Liverpool City Council

Liverpool Civic Place Stage B
& C

**Access Review –
Final**

10th December 2020

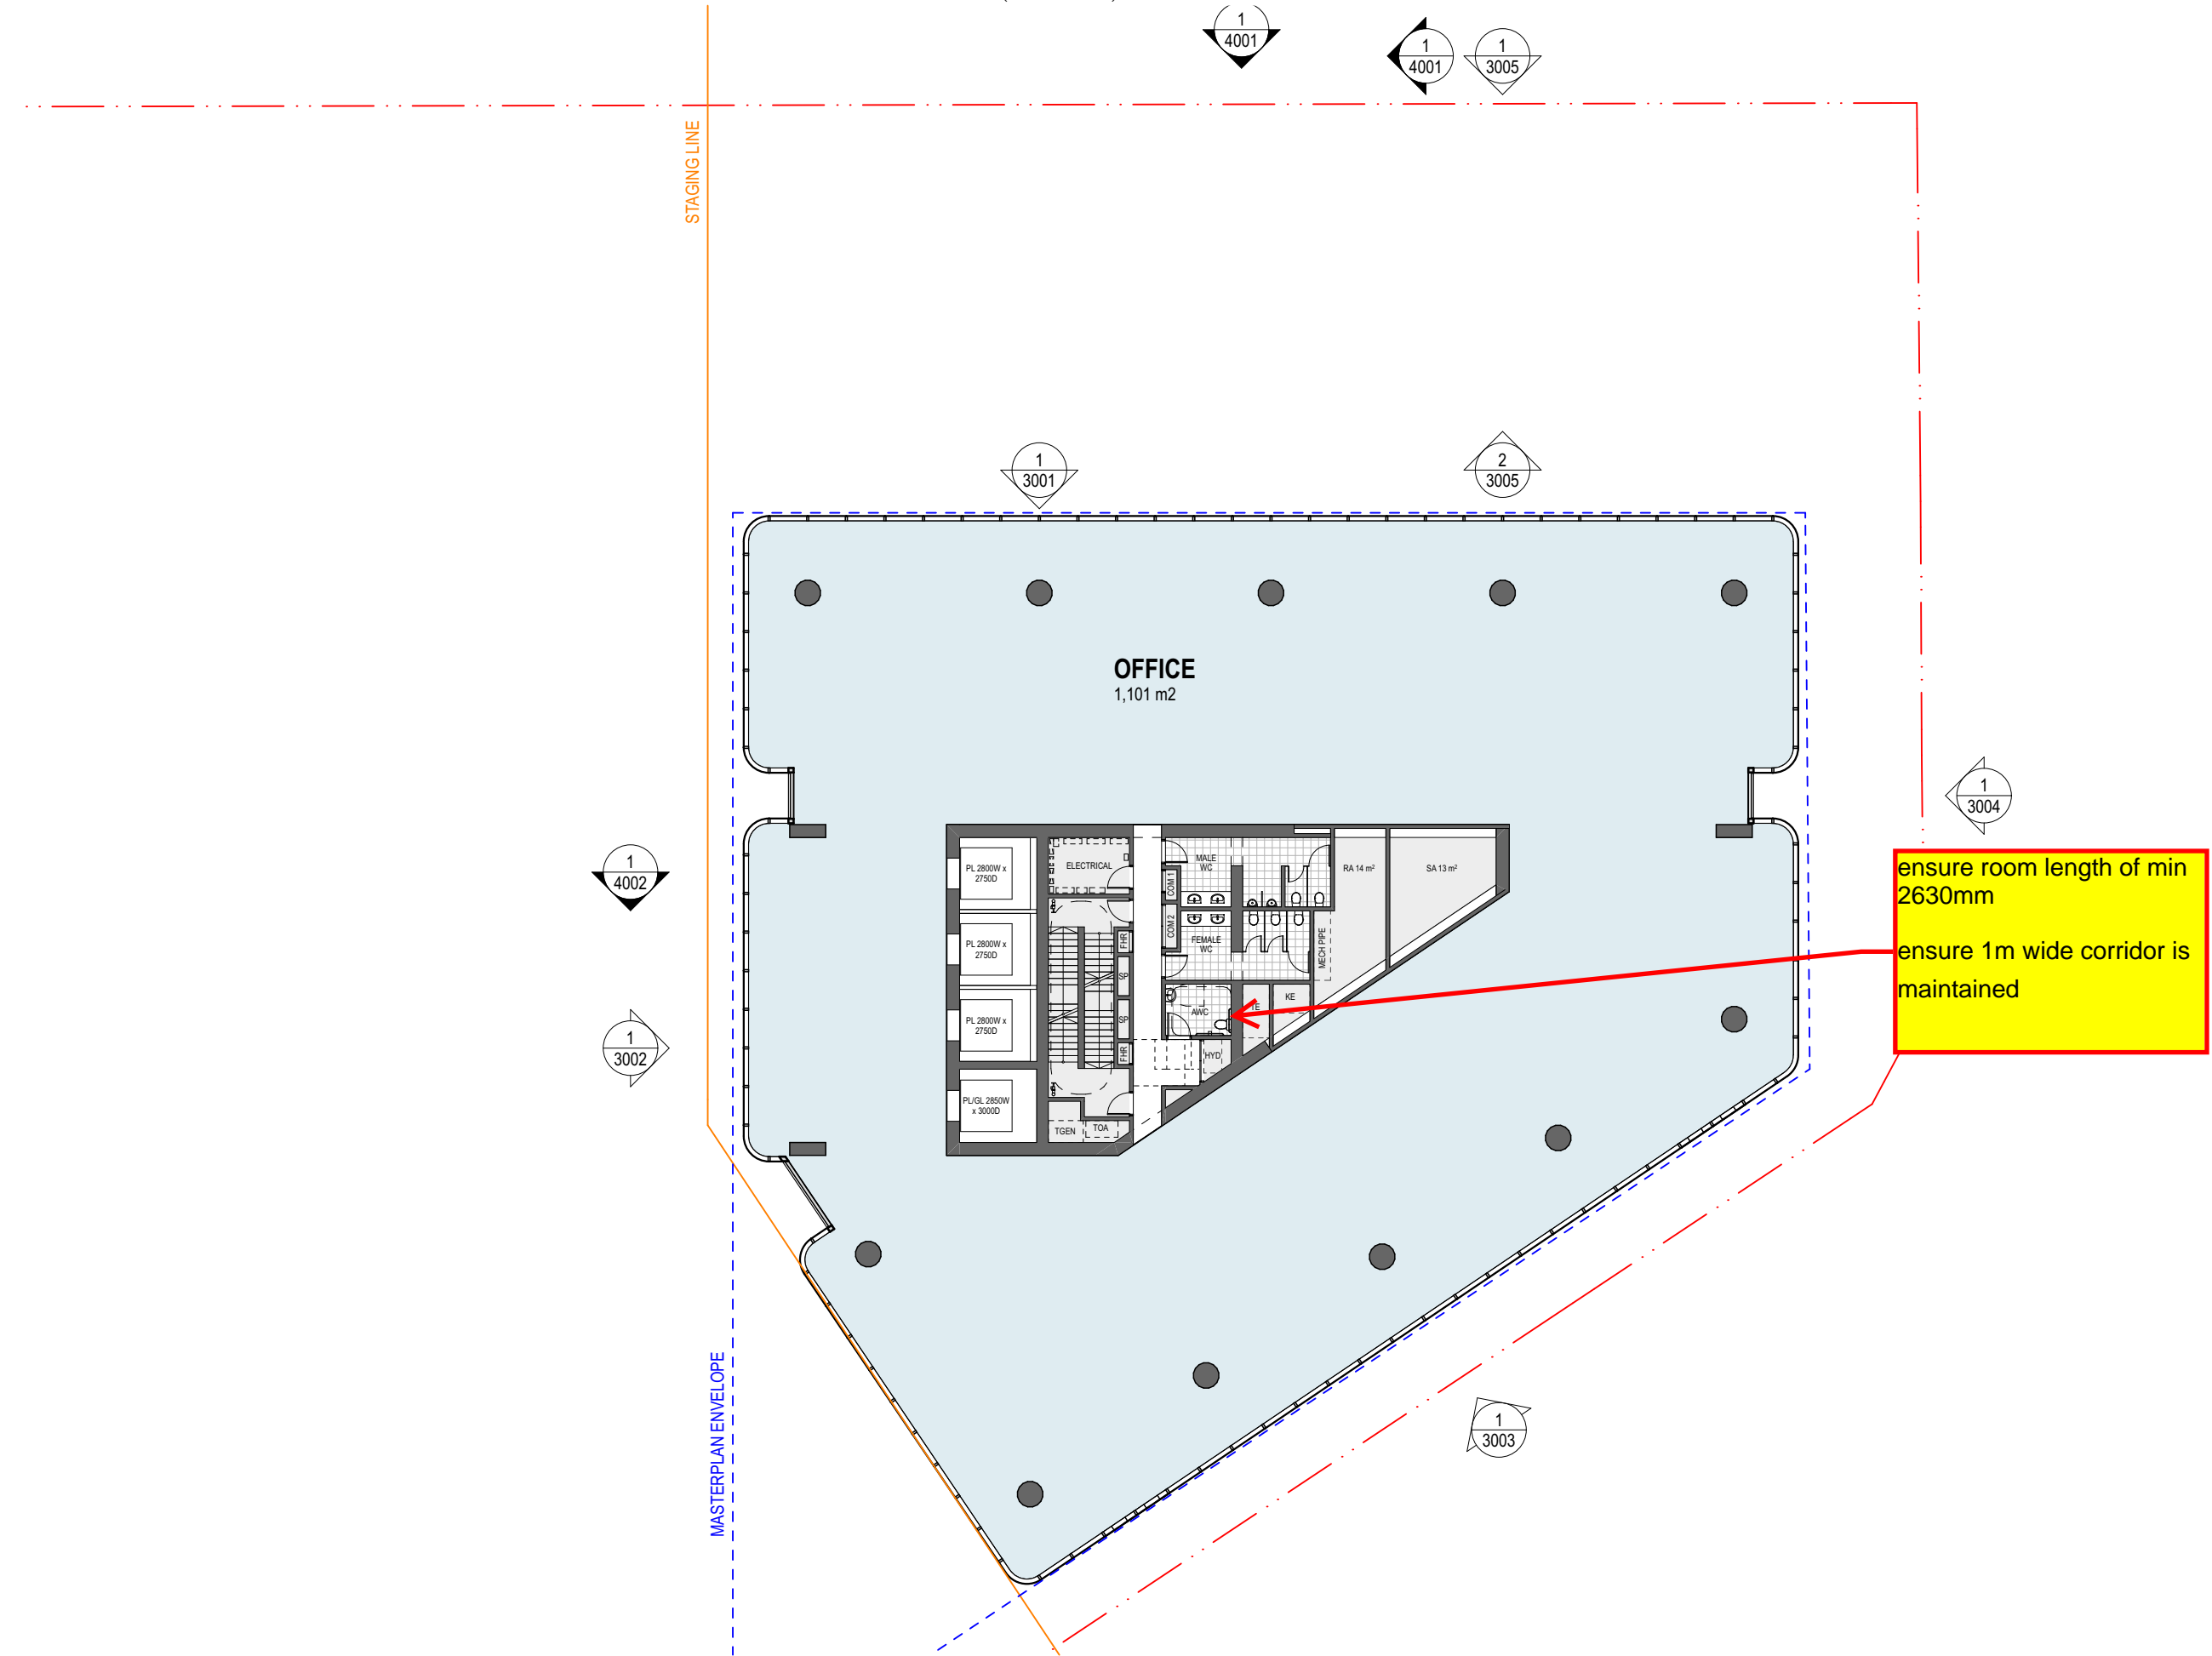
1. 1m clear width required either side of the bed
2. width of AWC to be 2350mm - currently measures 2300mm.
3. AWC to be reviewed - ensure min 2630mm x 2350mm internal demesion.
4. Ensure level access required onto balcony.
